## DESIGN COMMISSION REGULAR MEETING AGENDA

# Design Commission Design Review

<b>Project No:</b>	DSR18-004
<b>Brief Description:</b>	Study Session
<b>Location:</b>	2856 80 <sup>th</sup> Ave SE Mercer Island WA 98040; Identified by King County Tax Parcel #5452300540
<b>Applicant:</b>	Scot Carr, PUBLIC47 Architects
<b>Staff Contact:</b>	Robin Proebsting, Senior Planner

Mercer Island Design Commission Study Session  
November 14, 2018

EXTERIOR MATERIALS (19.11.110)

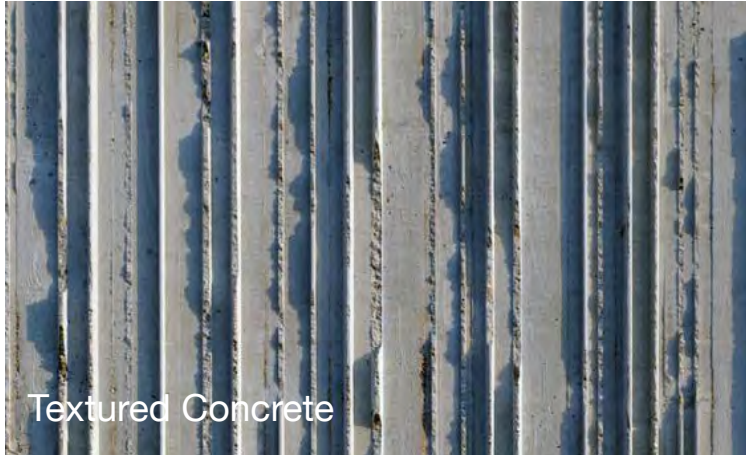
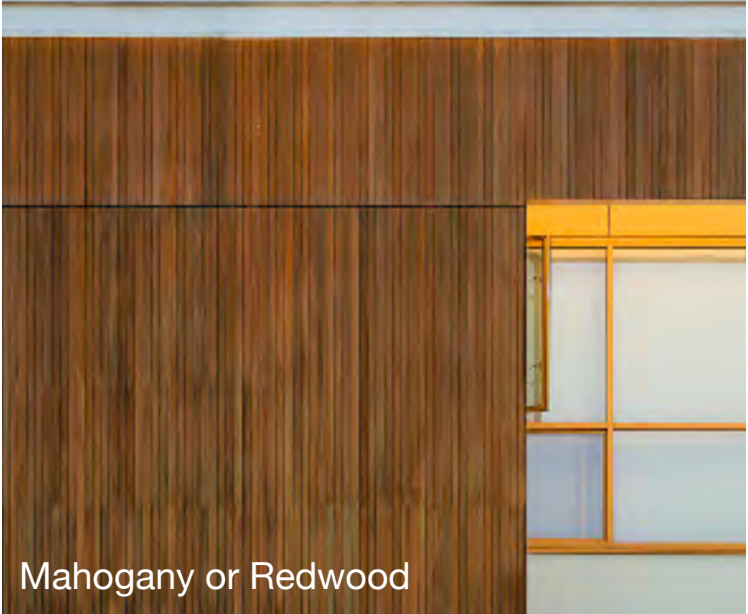
1. Applicant Question #1: Do the proposed exterior materials meet the intent of MICC 19.11.110 - Materials and Color?

Please confirm the proposed exterior materials meet the objectives of code section 19.11.110 Materials and Color?

**Staff analysis:** *MICC 19.11.110 sets criteria for the materials and color that may be used on the exterior of buildings in Town Center, as well as the way in which materials and color should be used. The proposed use of materials and color (see Exhibit 3, sheets 10-11) appear to meet the relevant criteria, based on the analysis below:*

<b>Standard</b>	<b>How addressed:</b>
1. Building Exteriors. Building exteriors should be constructed from high quality and durable materials. It is important that the materials and colors weather well and that building exteriors need minimal maintenance.	<i>The building is proposed to use high quality, durable materials like brick, treated concrete, and wood, consistent with this criterion.</i>

2. Regional Focus. Materials and colors should reflect the city's regional setting.	<i>The material choice and building design evoke a northwest modern look and feel, reflecting Mercer Island's regional setting.</i>

3. Attention to All Sides. Materials and colors should be used with cohesiveness and compatibility on all sides of a building.	<i>The proposed materials and colors are compatible with each other and provide a cohesive design on all sides of the building.</i>

4. Concrete Walls. Concrete walls should be architecturally treated. The treatment may include textured concrete such as exposed aggregate, sand blasting, stamping or color coating.	<i>All concrete walls are architecturally treated.</i>

5. Harmonious Range of Colors. A harmonious range of colors should be used within the Town Center. Neon or very bright colors, which have the effect of unreasonably setting the building apart from other adjacent buildings on the street, should not be used.	<i>Colors shown in the renderings are harmonious, and do not include neon or very bright colors</i>

6. Bright Colors. Bright colors should be used only for trim and accents if the use is consistent with the building design and other design requirements.	<i>No bright colors are proposed.</i>

7. Undesired Materials. Beveled metal siding, mirrored glass, and vinyl siding should not be used. EIFS, stucco and similar materials should be limited to use as a minor building facade element.	<i>The design does not use any of the materials listed as undesirable.</i>

8. Variation of Materials. A variation of building materials should be used to assist in the creation of a visually interesting experience. (Ord. 16C-06 § 2 (Exh. A)).	<i>The design uses varied materials, including brick, wood, and treated concrete.</i>

PROPOSED SIDEWALK AND OVERHANG

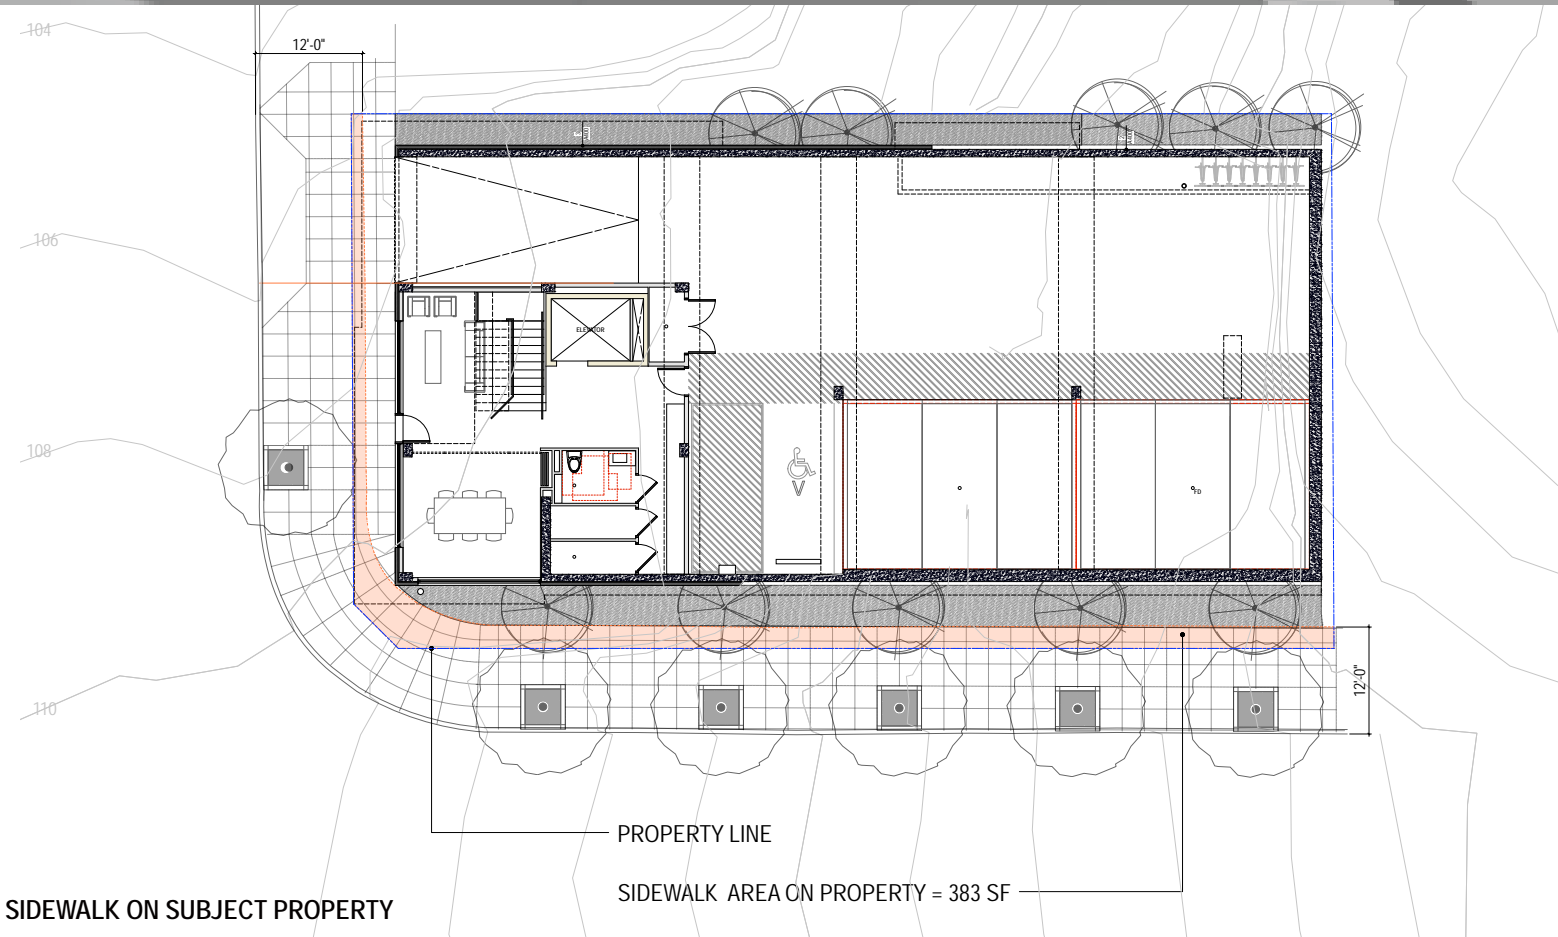
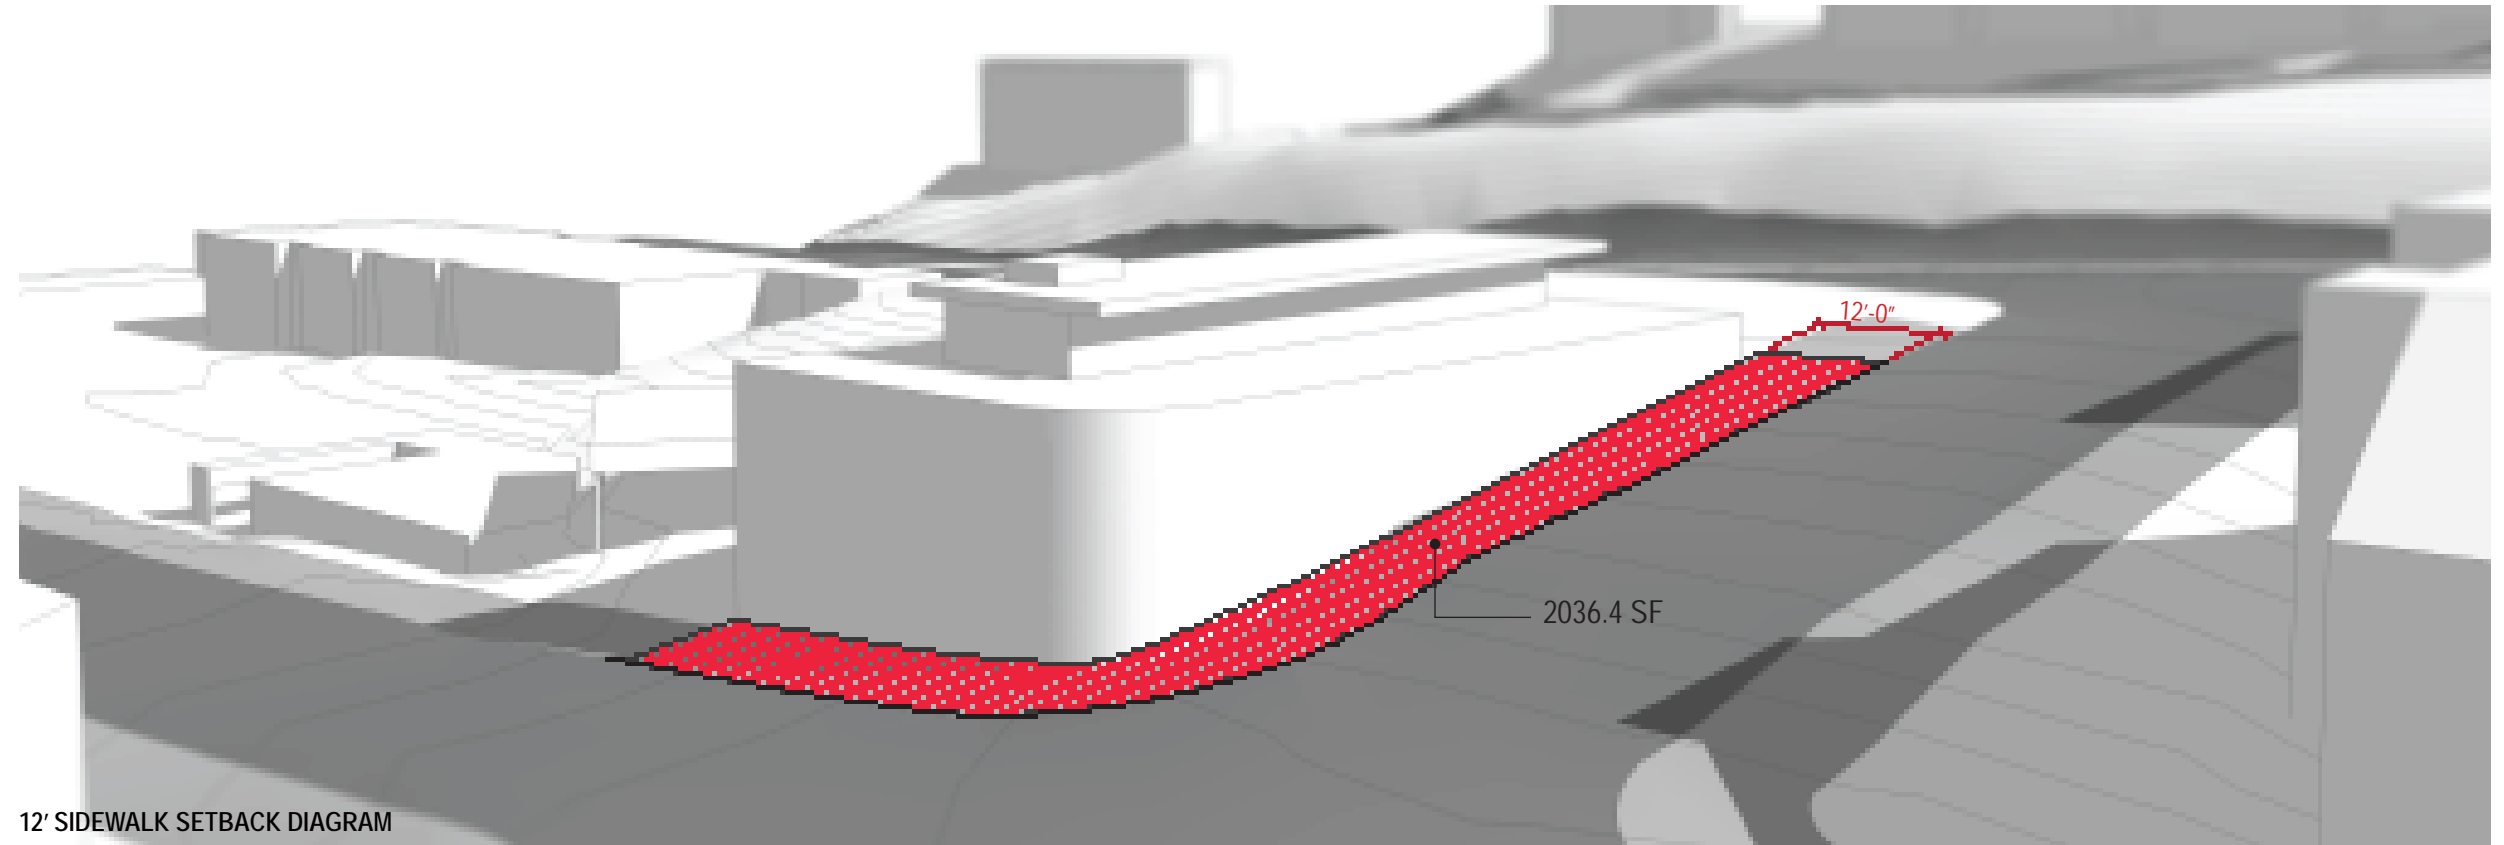
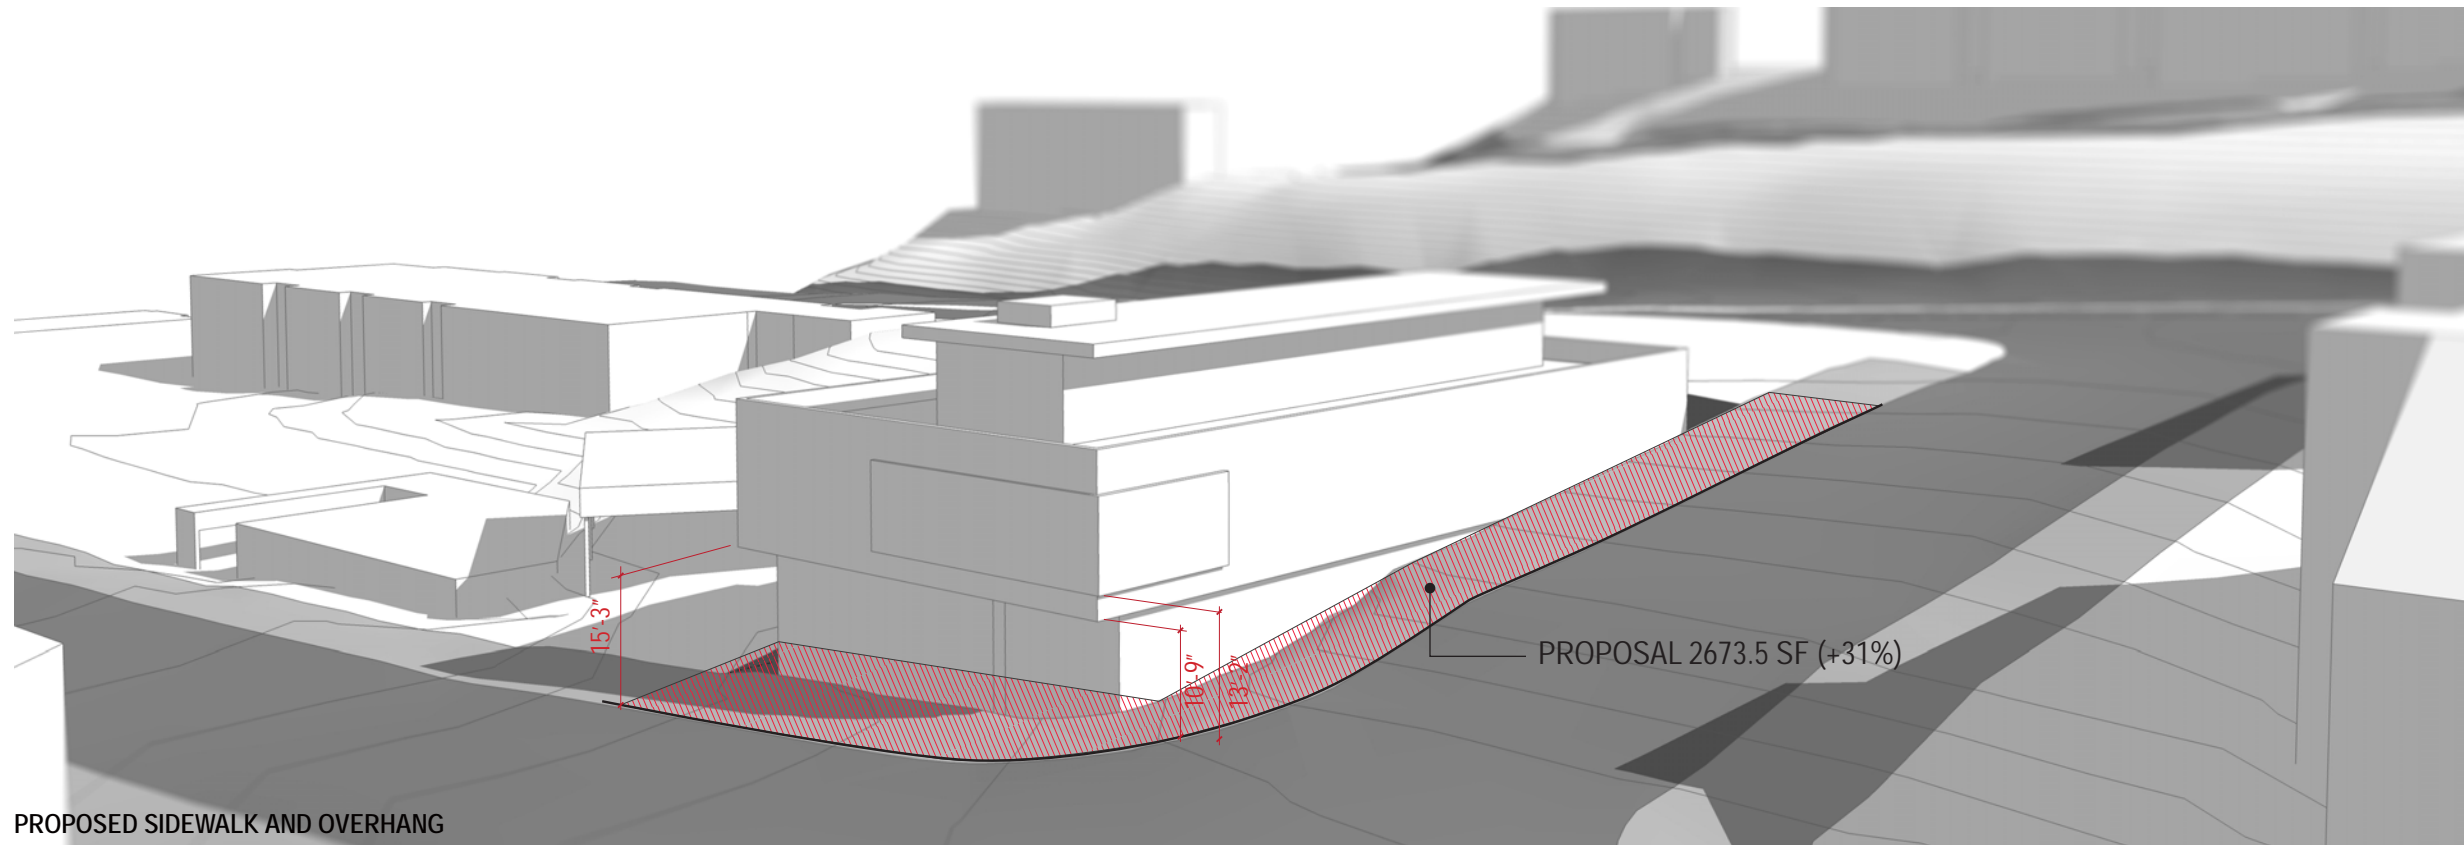
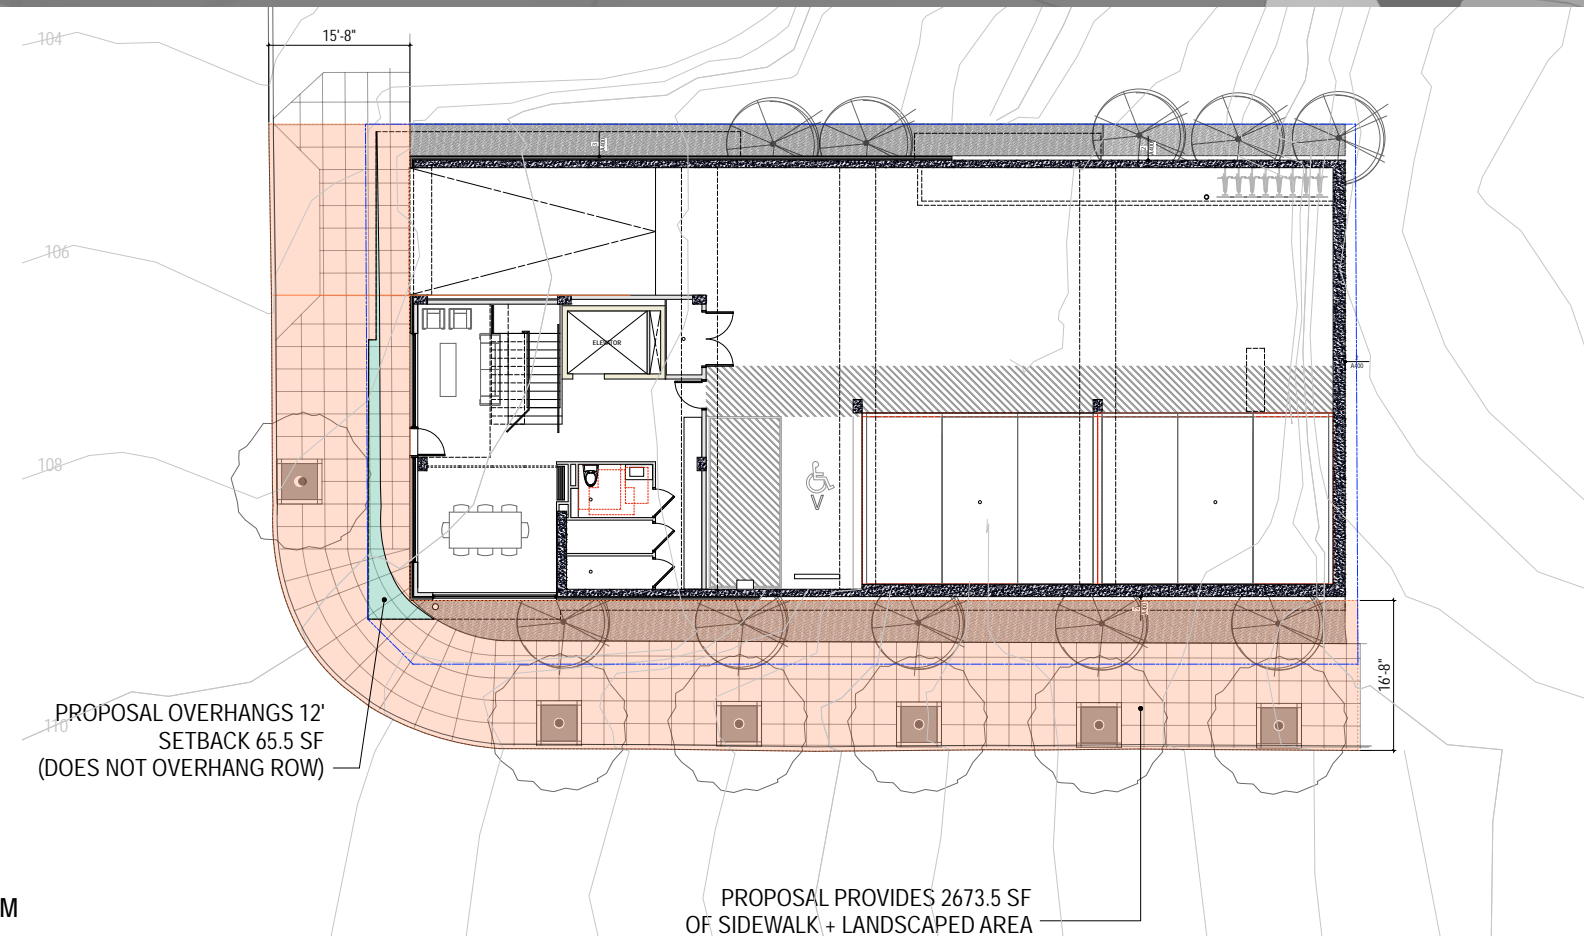
2. Applicant Question #2: Is the proposed extension of the second level over the sidewalk consistent with the code?

**Staff analysis:** *At the previous study session on this project in April 2018, the applicant proposed extending the second level of the building roughly 8 feet over the 12-ft wide area required for sidewalk. In response, some Design Commissioners supported the proposed overhang while others expressed discomfort at allowing any part of the building to be closer than 12 ft from the face of the curb. Commissioners also voiced the concern that allowing overhang in the 12 ft setback area could set a precedent, potentially causing unintended consequences for future projects.*

*To address this concern, the applicant has called out features that are unique to this property that would limit the applicability of precedent set by allowing overhang for this building. A combination of three attributes of the site present challenges to the building design: 1) the 25-ft curb radius at the intersection of 80<sup>th</sup> Ave SE and SE 30<sup>th</sup> St; 2) the chamfer corner at the SW corner of the property line; and 3) the comparatively small site of the lot. The applicant contends that the unique combination of these site constraints justifies the proposed building overhang.*

*Further, the applicant has revised the design to set the second level of the building further back from the face of the curb and higher up from the sidewalk area. The ground level of the building is sufficiently set back from the property line to allow for 15 ft 8 in of sidewalk, which is greater than the required 12 feet. The second level of the building will cover approximately 65.5 sq ft of the 12 ft sidewalk area, with the lowest point of the second level being 10 ft 9 in above the sidewalk below. A narrow portion of the second level structure is proposed to extend into the 12 ft sidewalk area, with the window framing projecting further over the sidewalk area, 13 ft 2 in above the sidewalk. Staff conclude that the design is consistent with MICC 19.11.030(A)(6) by providing sufficient space for 12 feet of sidewalk between the structure and the face of the street curb.*

*Lastly, the proposed building overhang fulfills requirements in other sections of MICC 19.11, including:*

- *MICC 19.11.100(B)(1)(c): The upper story maintains an expression line along the façade using a change of material and projection to reduce the perceived building mass.*
- *MICC 19.11.100(B)(6): The building entrance is recessed from the façade surface.*
- *MICC 19.11.100(B)(13): The proposed building overhang provides weather protection.*
